**PLANNING COMMISSION AGENDA
CITY OF PRAIRIE VILLAGE
TUESDAY, MAY 7, 2024
7700 MISSION ROAD
COUNCIL CHAMBERS
7:00 P.M.**

PC2024-101 Site plan review - accessory pickleball building and additional parking
Homestead Country Club
4100 Homestead Court
Zoning: R-1A
Applicant: Jeff Pflughoft, Hulsing Hotels

**PLANNING COMMISSION MINUTES
APRIL 2, 2024**

SHEET # **C2.0**

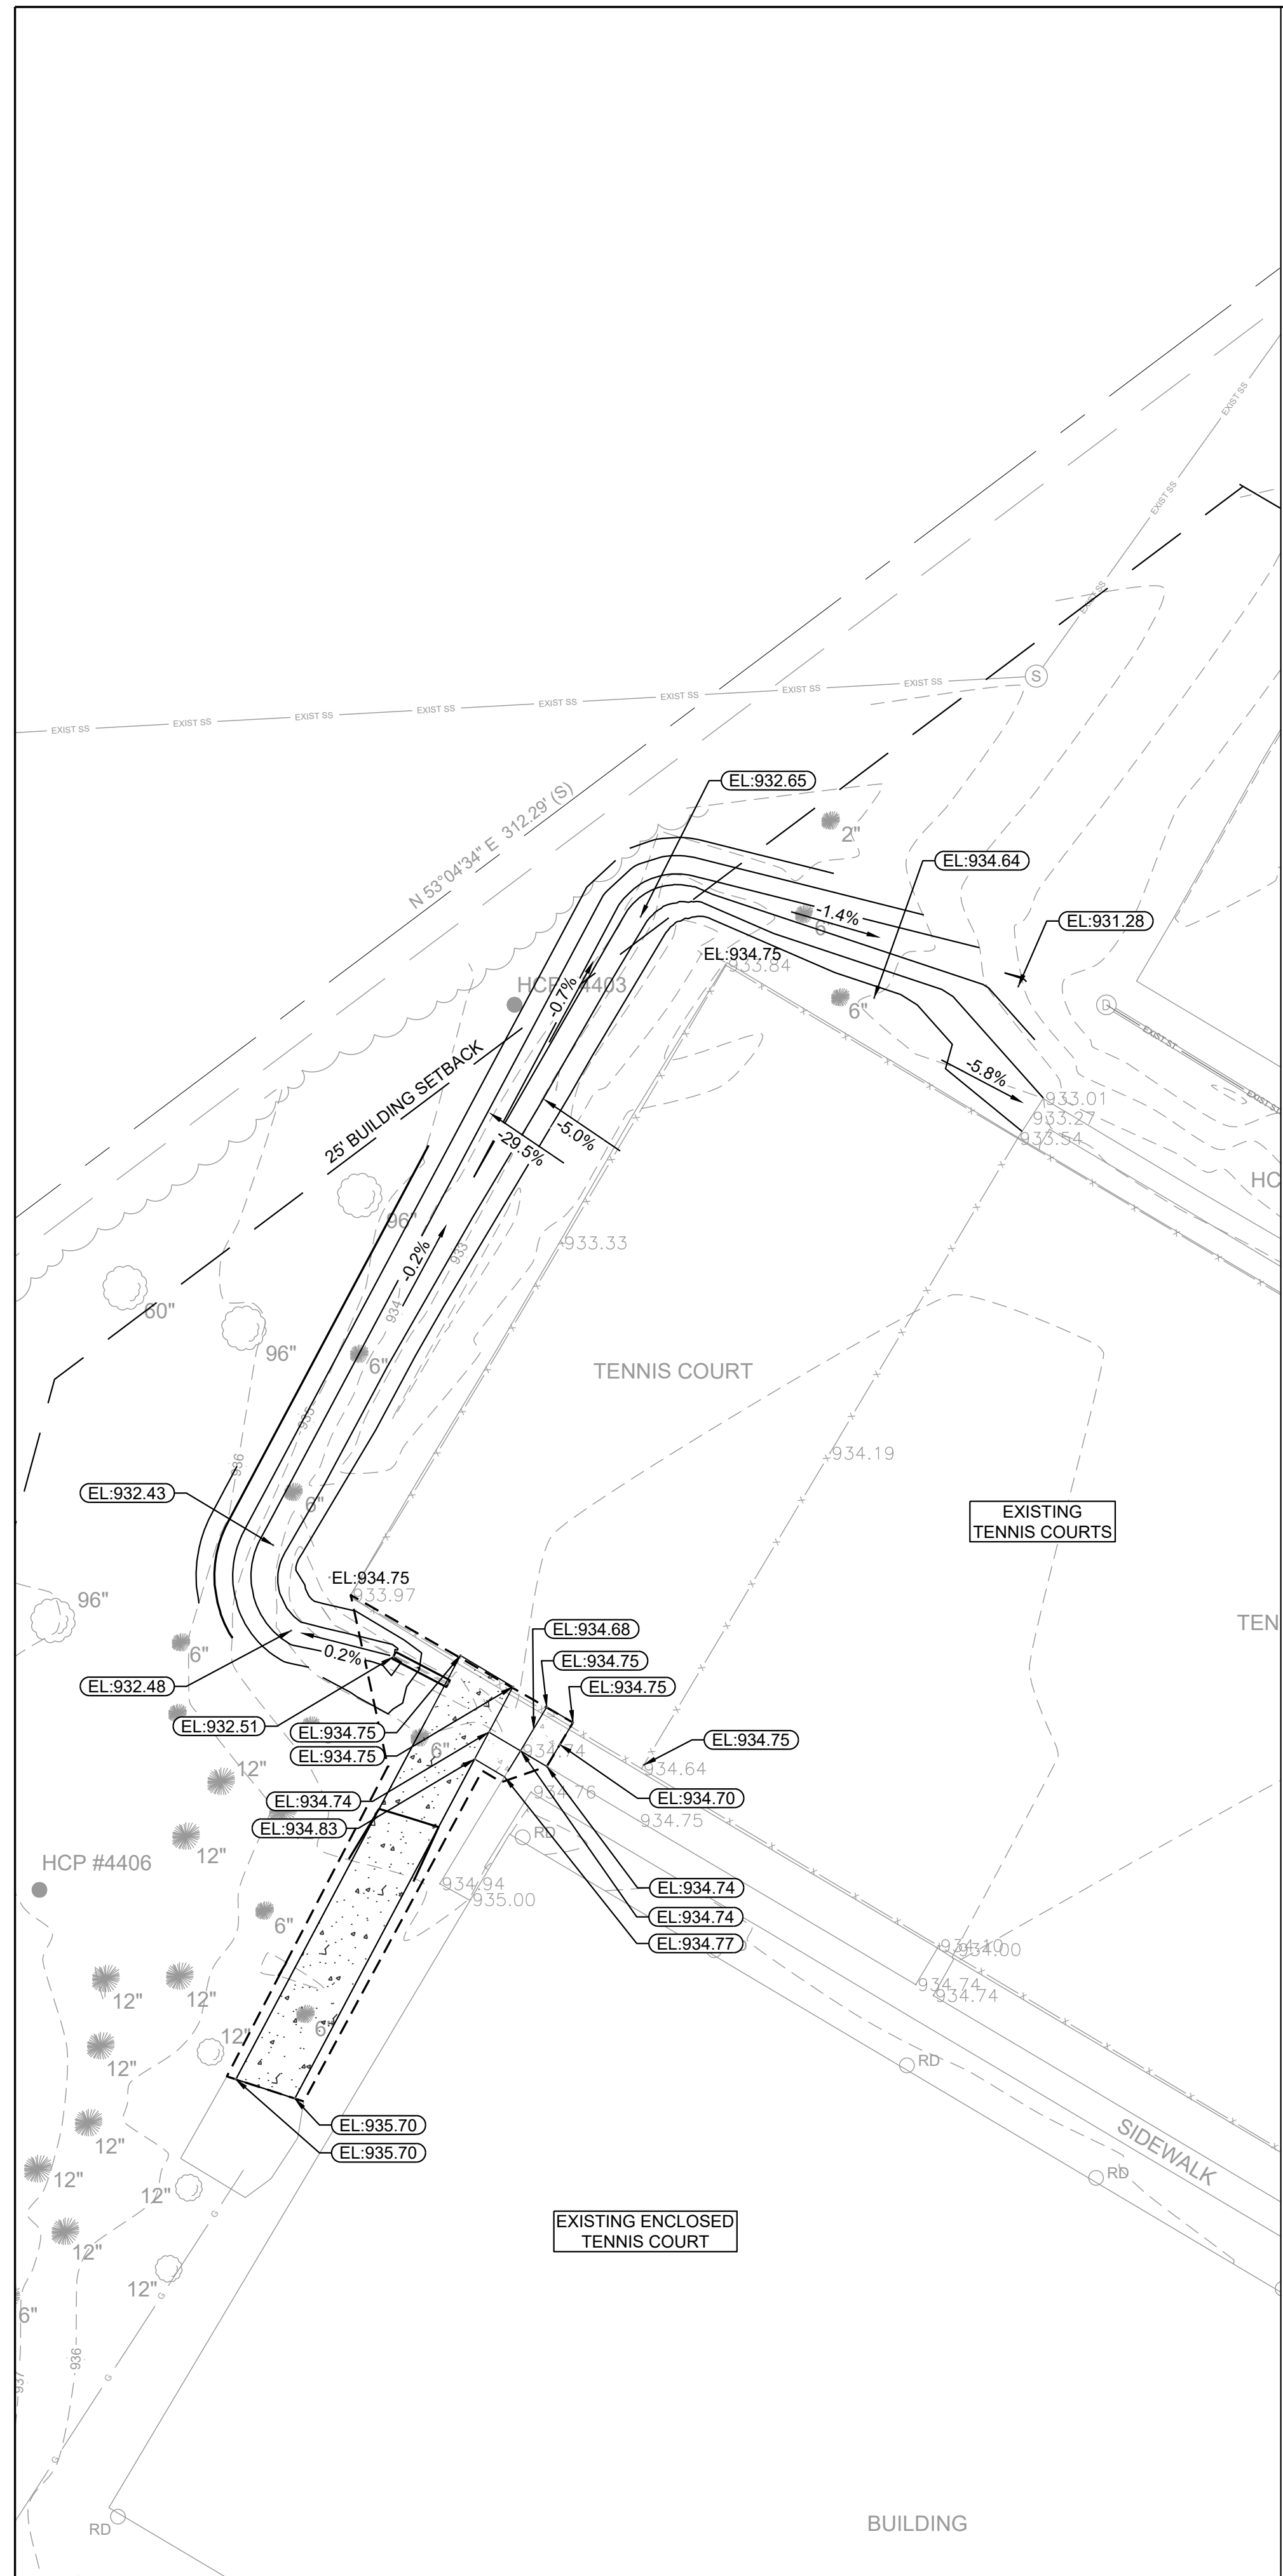
4. Sheet C2.0 (grading plan) includes an incorrect note from a prior plan indicating a “proposed enclosed pickleball court” in the northwest corner; and sheets C5.0 and 5.1 (erosion control plan and details) include an incorrect note from a prior plan indicating a “proposed enclosed pickleball court” on the west most tennis court. These are not part of the plan and no buildings in these areas are being proposed or considered. These notes should be removed from all further plans or permit documents.
-
